JAN–I–8
AMENDMENT—2

21 JULY 1954

JOINT ARMY-NAVY SPECIFICATION

INSULATORS, STEATITE, RADIO

Figure 6a. Steatite radio insulators—square pillar insulators.

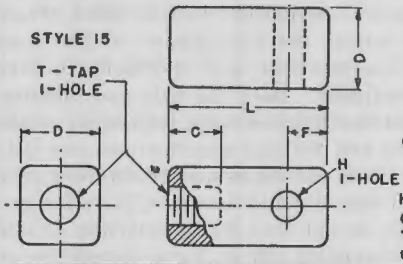
Page 17: After figure 6, add the following new figure 6a :

TYPE DESIGNATION TO BE IN THE FOLLOWING FORM:

NS 3 W 15 07

Component (D-3a) Grade (D-3b) Finish (D-3c) Style (D-3d) Part (D-3e)

Heavy lines indicate glaze when specified.
Countersink all tapped holes.
Tolerances on all dimensions shall be as specified herein, unless otherwise indicated.

Figure 14. Steatite radio insulators.

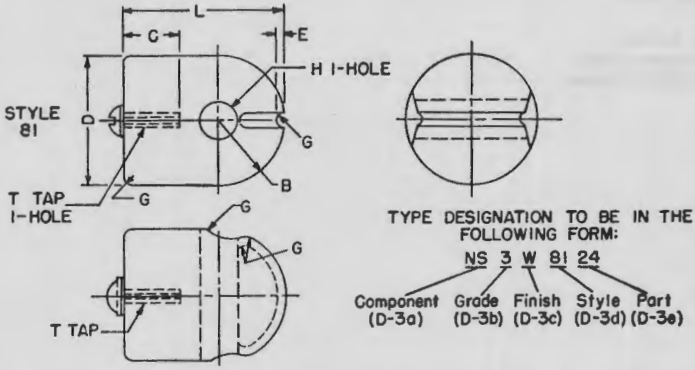
Page 27: After figure 13, add the following new figure 14 and patent notice:

Tolerances on all dimensions shall be as specified herein, unless otherwise indicated

Glaze all over except base. Lockwasher, shakeproof, cadmium plated brass, or equal. Screw, cadmium plated brass.
